TOWN OF ADDISON
 BUILDER'S COPY OF PLANS
 This set of plans contains various corrections and comments
 made by the City Staff. All trades will be required to comply
 with these corrections and comments. Failure to inform
 all trades of this information will not be accepted as a reason
 to approve construction which is in violation of local
 ordinances.
 This set of plans is to be kept on the job site at all times
 and is to be made available for use by city inspectors at
 their request. Failure to have these plans available may
 delay approval of a requested inspection.

01 FIRST FLOOR PLAN - PLUMBING
 P2.1

**ADDITION TO
 PUBLIC WORKS SERVICE CENTER**
 Westgrove Road
 Addison Texas

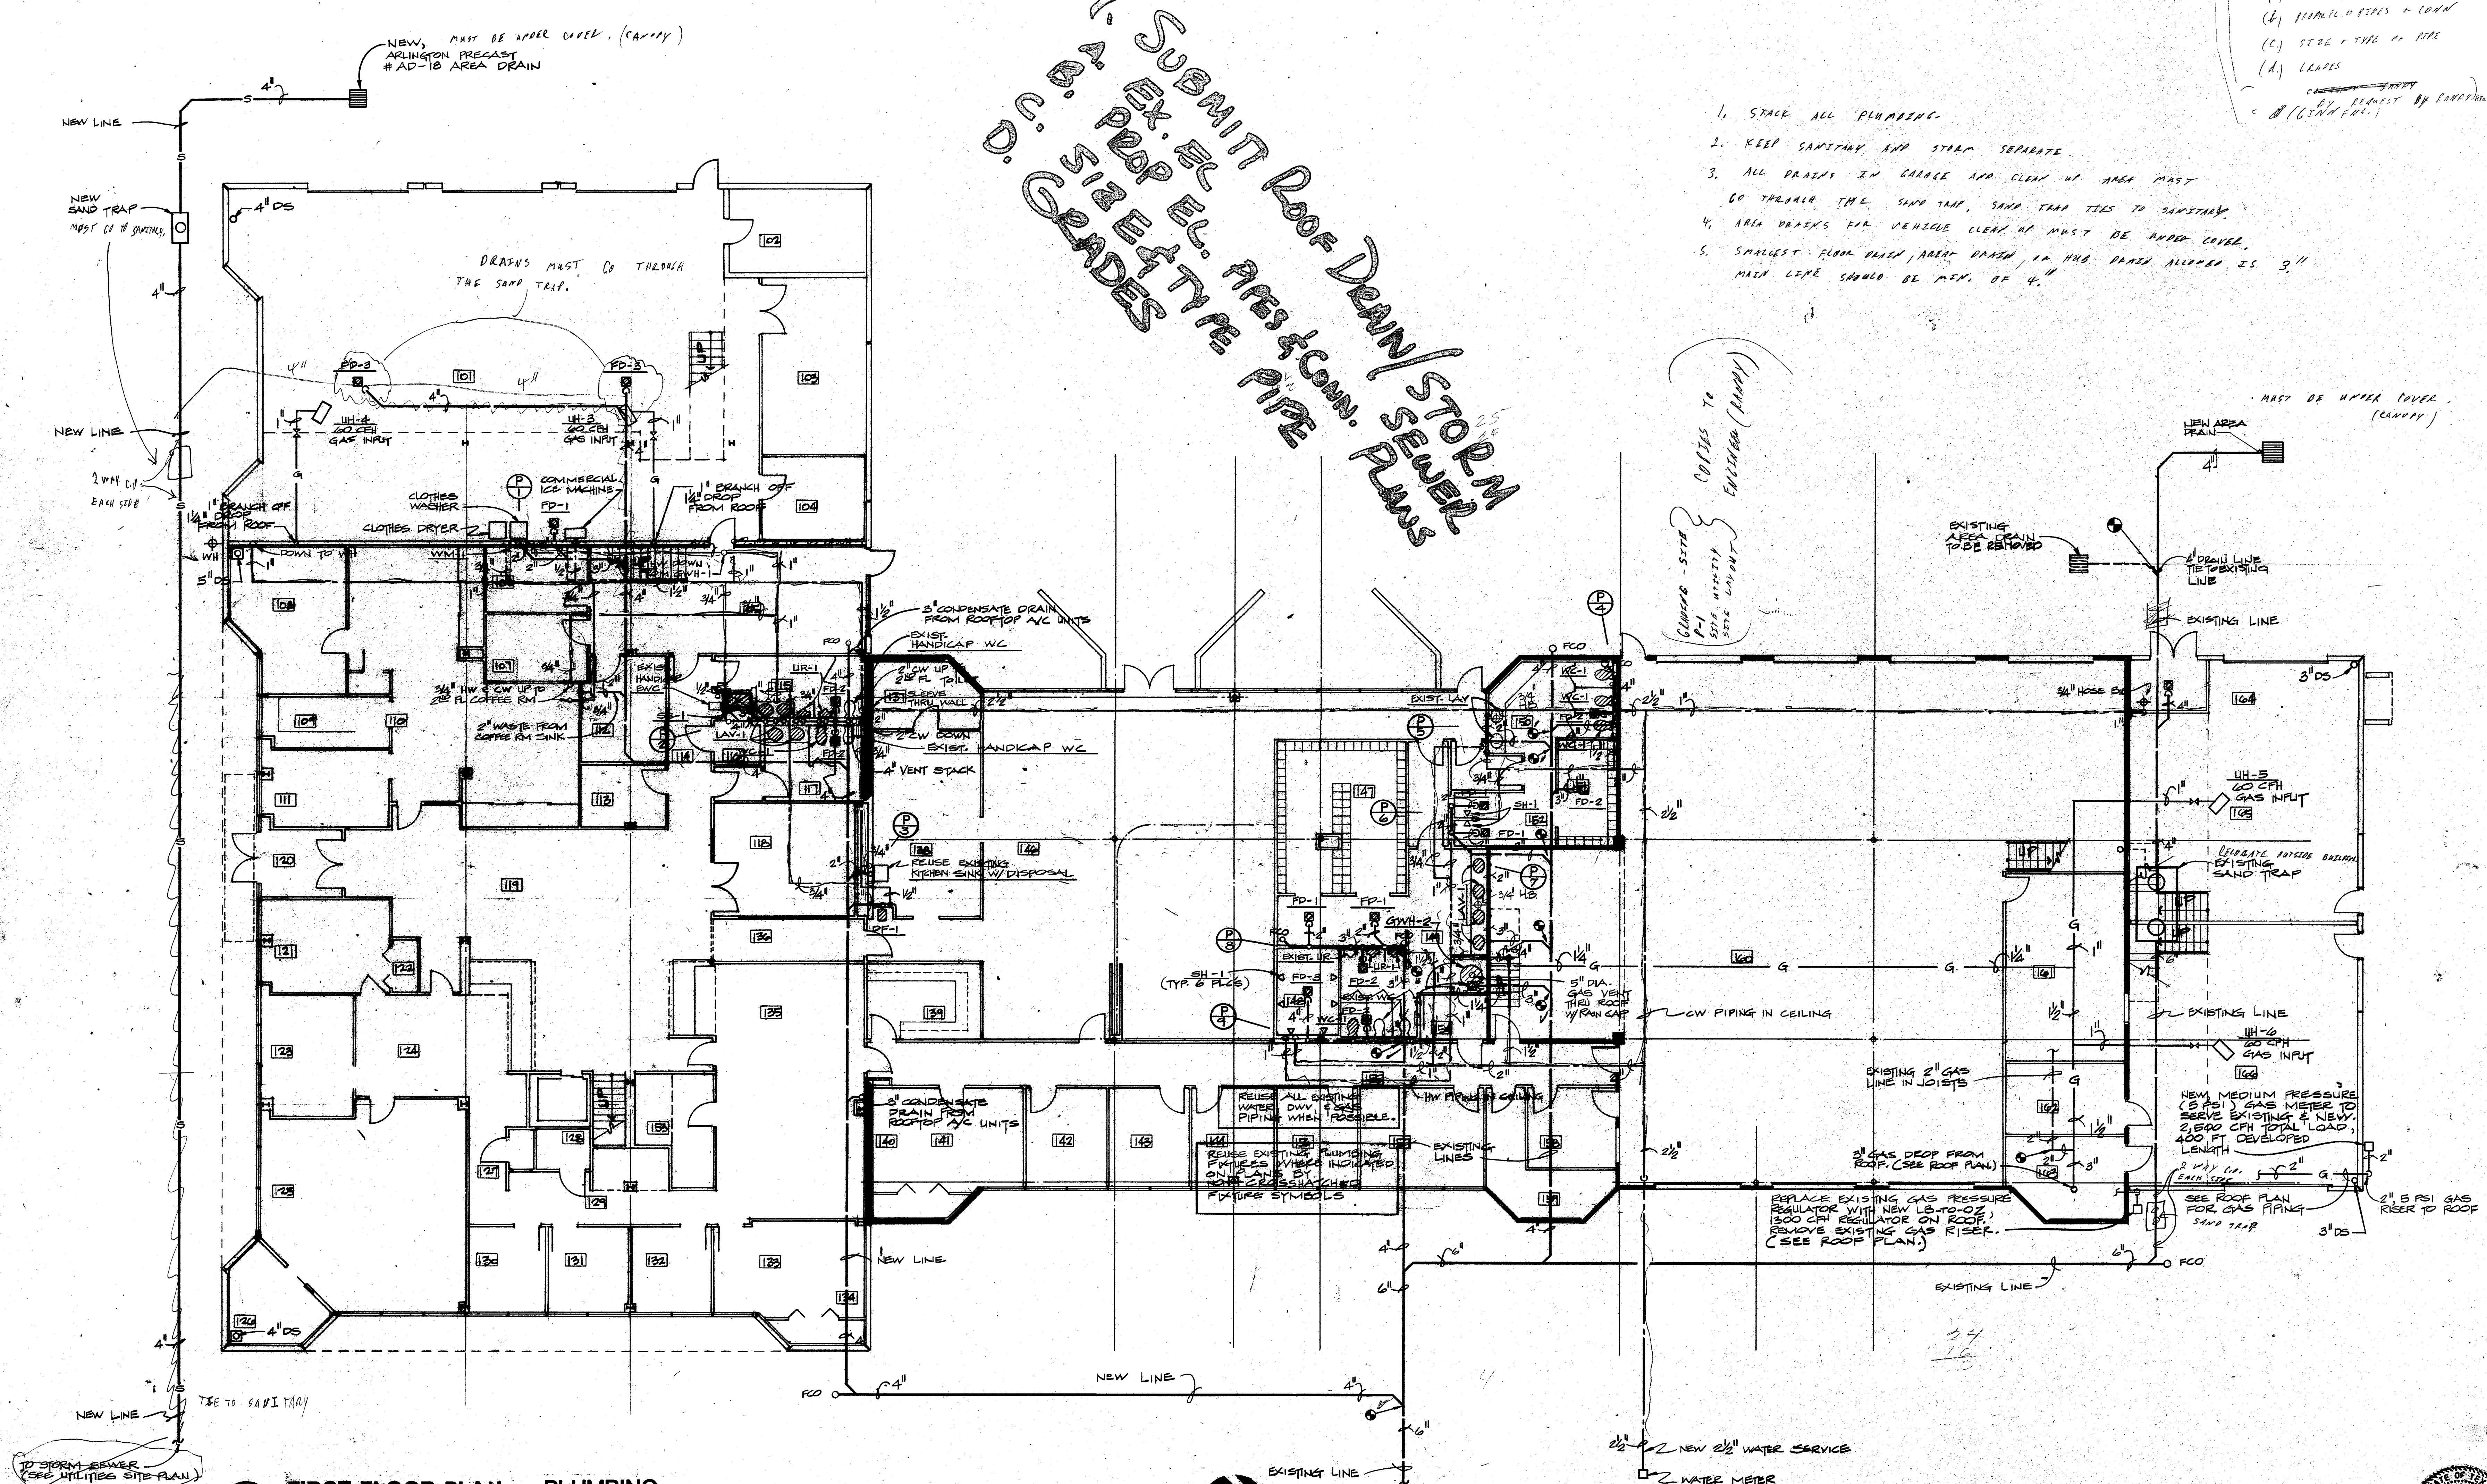
PLUMBING ISSUED IN FULL SCALE CONTRACTS
 NO UTILITIES TO BE
 INSTALLED UNTIL THE
 FOLLOWING PLANS ARE SUBMITTED
 AND APPROVED BY ENGINEER
 AND UTILITY COMPANIES.

1. COMPLETE SITE PLANS
2. P-1 (REVISED PLUMBING PLANS)
3. SITE UTILITY PLANS
4. SITE LAYOUT PLANS

1. SUBMIT ROOF DRAIN/STORM SEWER PLANS
2. EX. EL. PIPES & COMM. SEWER PLANS
3. SIZE & TYPE PIPE GRADES

1. STACK ALL PLUMBING.
2. KEEP SANITARY AND STORM SEPARATE.
3. ALL DRAINS IN GARAGE AND CLEAN UP AREA MUST GO THROUGH THE SAND TRAP, SAND TRAP TIES TO SANITARY.
4. AREA DRAINS FOR VEHICLE CLEAN UP MUST BE UNDER COVER.
5. SMALLEST FLOOR DRAIN, AREA DRAIN, IN HUB DRAIN ALTHOUGH IS 3" MAIN LINE SHOULD BE MIN. OF 4".
